SERVICE BULLETIN

MODEL NAME : Di620
MODEL CODE : 1155
NO. : 040
DATE : 990729
SUBJECT : HARNESS CHANGE

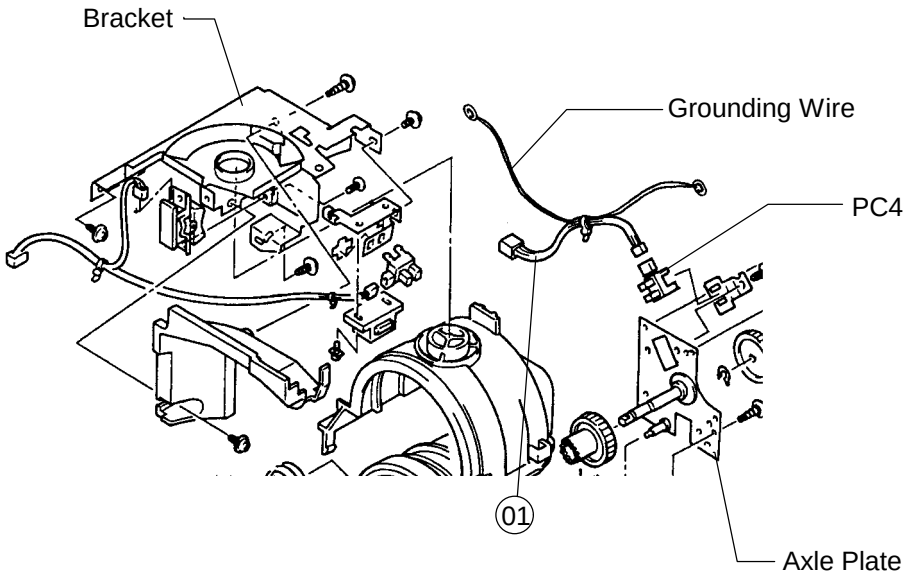
To protect the toner bottle home position sensor (PC4) from static electricity, a grounding wire has been added to the harness (01). The grounding wire is secured with the bracket and axle plate.

NO.	BEFORE MODI. F-IND	BEFORE MODI. PART NO.	AFTER MODI. PART NO.	AFTER MODI. F-IND	PART NAME	QTY →		I	SE/NO.	AREA
01	16-46AB	1155-6861-01	1155-6861-02	16-46AC	WIRE HARNESS ASSY	1	1	Y	012513	0000
